**IN THE SUPERIOR COURT OF THE STATE OF ARIZONA
IN AND FOR THE COUNTY OF MARICOPA**

Affidavit of Peter M. Pyle, PG, CHG

Arizona Department of Water Resources, Subflow Delineation Report for the San Pedro River Watershed, June 2009

Floodplain Holocene Alluvium Boundary within Bedrock defined by ADWR, 2009
 (portion of Lewis Springs quad)

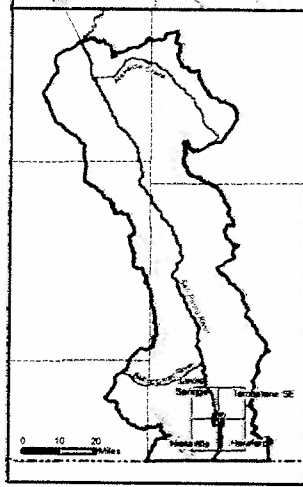
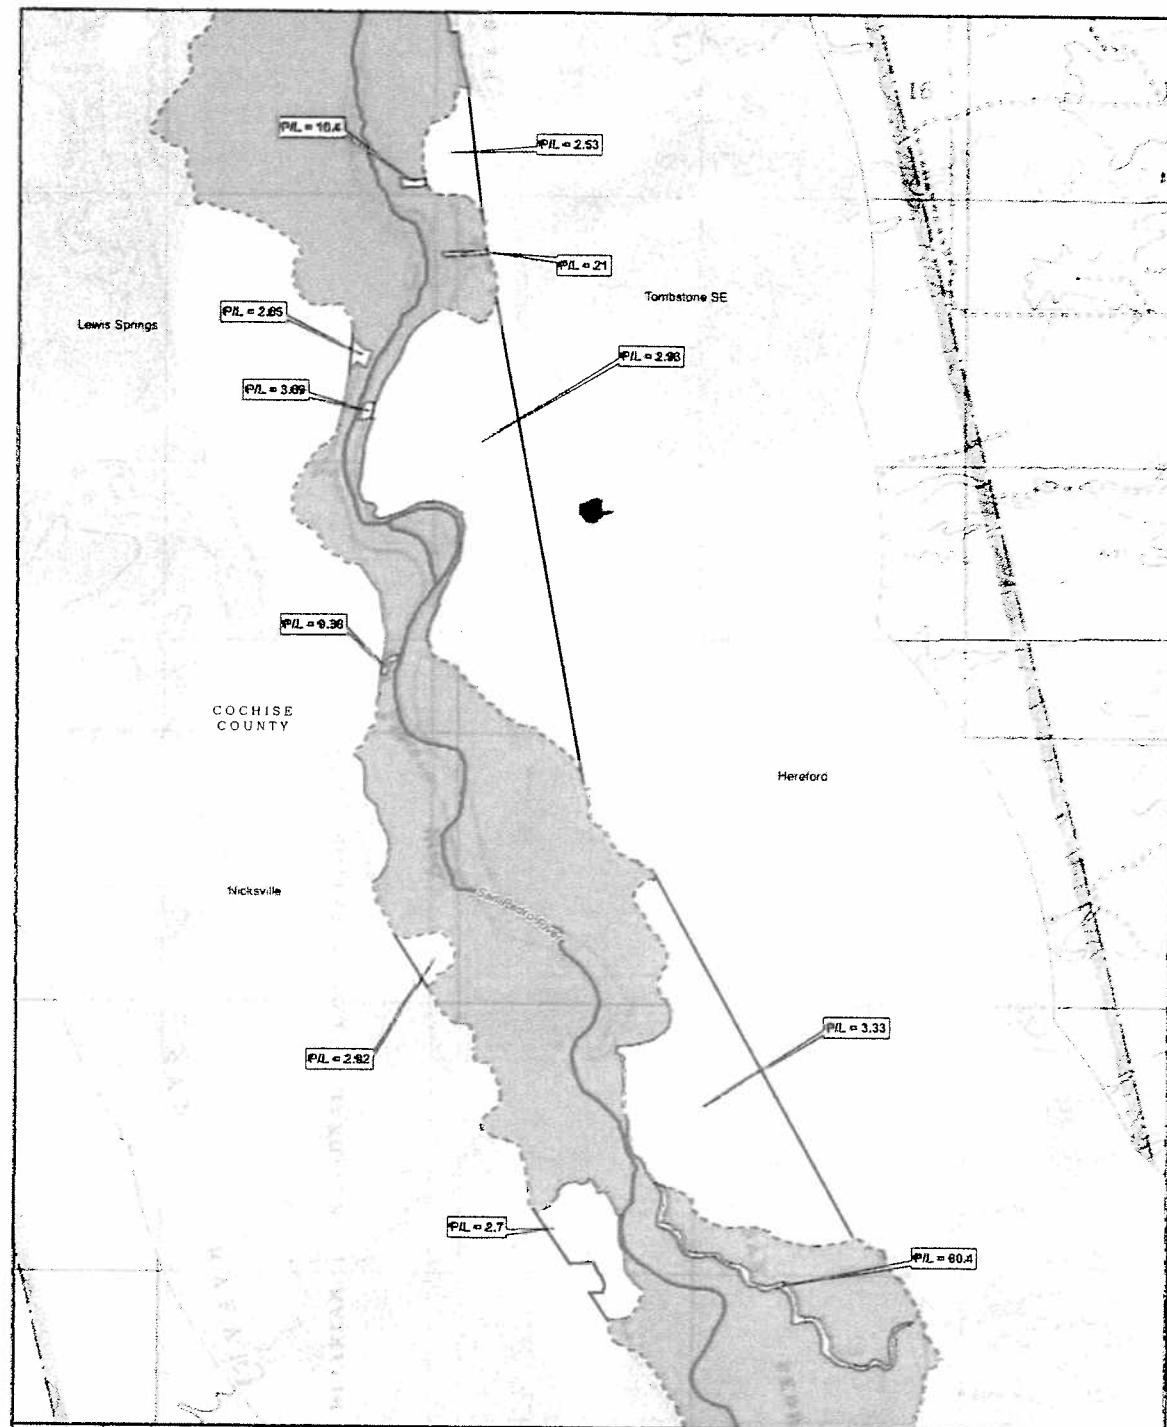
1
2 However, ADWR appears to have reduced the width of the subflow boundary or
3 eliminated it entirely where the San Pedro River flows through two areas of bedrock in the
4 northern part of the Lewis Springs quad as shown in a comparison of Appendix D1 - Map 19 and
5 Appendix D3 - Map 19.

6 A review of the AZGS (2009, DGM-57, V2) revised Lewis Springs geologic quad shows
7 an example of where the River flows through an area of bedrock with deposits of Holocene
8 floodplain alluvium (Attachment C, this affidavit). There are also insignificant deposits of
9 undifferentiated Pleistocene alluvium (Qi) to which ADWR has applied a setback of 200 feet
10 which narrows the subflow boundary in that area to zero. San Pedro River subflow must occur in
11 at least the Holocene alluvium in this reach, highlighting the problem with applying setbacks in
12 all areas. The flow direction test described above and shown in Attachment B would confirm that
13 groundwater in this segment flows in the direction of the river in the Holocene alluvium, but it is
14 unnecessary because it can be inferred based on existing data and experience. The subflow
15 boundary should be extended through this bedrock area and no setbacks should be applied.

Figure D-4a
Application of ADWR Criteria to Address Tributary Holocene Alluvium Mapped Within the San Pedro River Floodplain

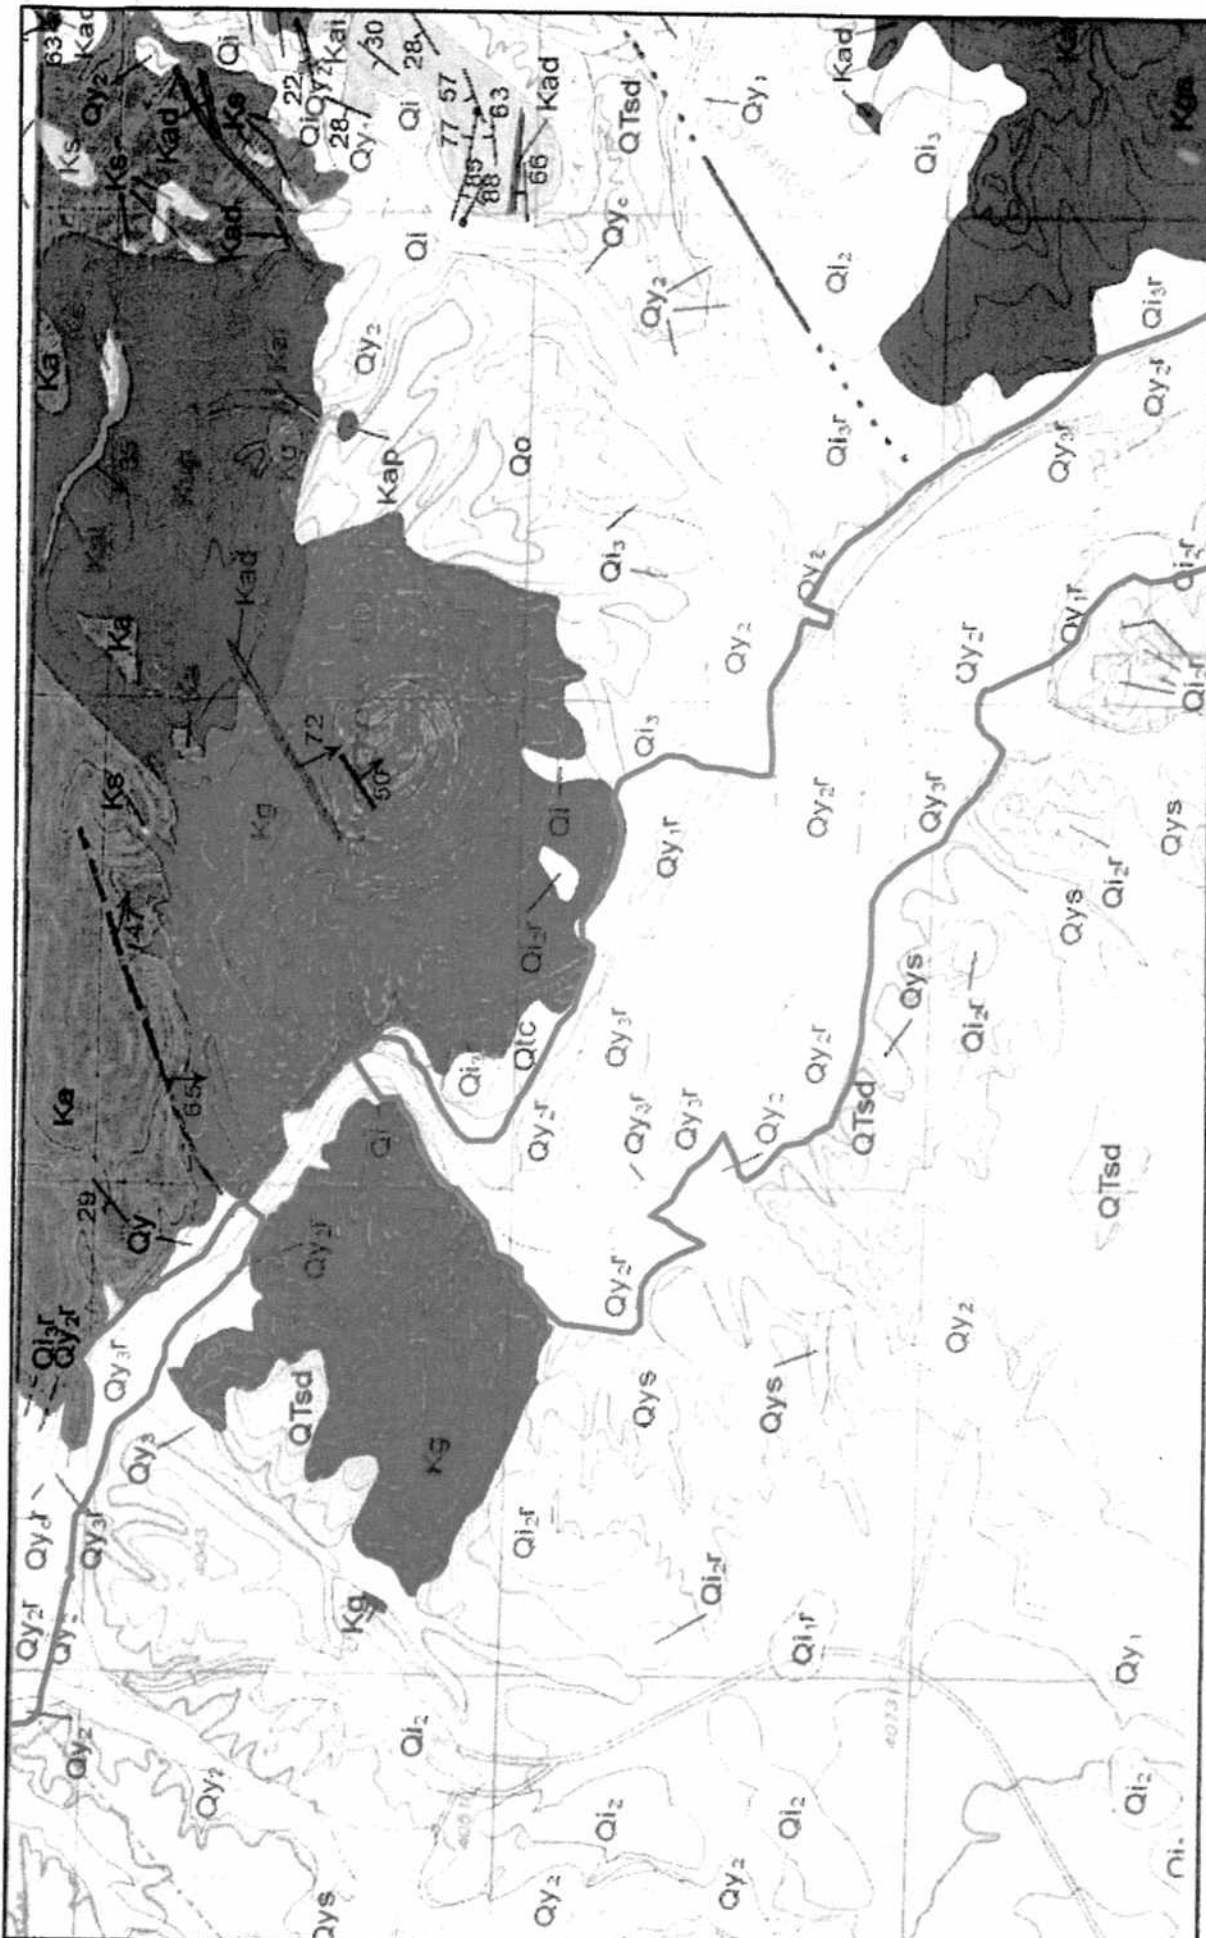
15 ADWR's (2009) suggested method for developing a more regular subflow boundary is
16 presented in their Appendix D-4. An example of this approach is shown in Figure D-4a (enclosed
17 herein as Attachment A). It involves an equation or ratio of the perimeter of the excluded feature
18 to its length at the edge of the floodplain. One problem with this is that the length at the edge of
19 the floodplain is a straight line joining two random points unrelated to geology or the floodplain
boundary and is entirely arbitrary. This approach fails to recognize that earth processes such as
sediment deposition and stream geomorphology are not readily approximated by simple equations
and linear features. Stetson Engineers strongly disagrees with this approach.

18 The boundary of Holocene alluvium in the San Pedro River floodplain may be more
19 difficult to define in some places rather than others due to limited basin fill or bedrock outcrops,
20 and low topography. However, this example shows that the proposed approach to defining the
21 Holocene floodplain alluvium, regardless of its source, would serve the intent of the court better
22 than, 1) the floodplain Holocene floodplain alluvium (subflow) boundary drawn by ADWR
23 (2009, Appendix D-3), or 2) ADWR's suggested approach to redefining the boundary in some
24 areas described in Appendix D-4, Figure D-4a (Attachment A of this affidavit).

20 We believe the most appropriate criteria to use from this point forward is to define the San
21 Pedro River floodplain based on geology, topography and geomorphology and the direction of
22 flow within the Holocene alluvium. Initially this approach will allow drawing a boundary that
23 includes mapped Holocene alluvial deposits within the San Pedro River floodplain which contains
subflow by the Court's definition. If there is any doubt as to the boundary in some areas of
Holocene alluvium, then the general direction of groundwater flow within it should be determined
24 by measurements or inferred from existing data and experience in similar areas. If groundwater
25 flow in the floodplain Holocene alluvium is in the direction of the San Pedro River, then the area
should be within the subflow boundary.
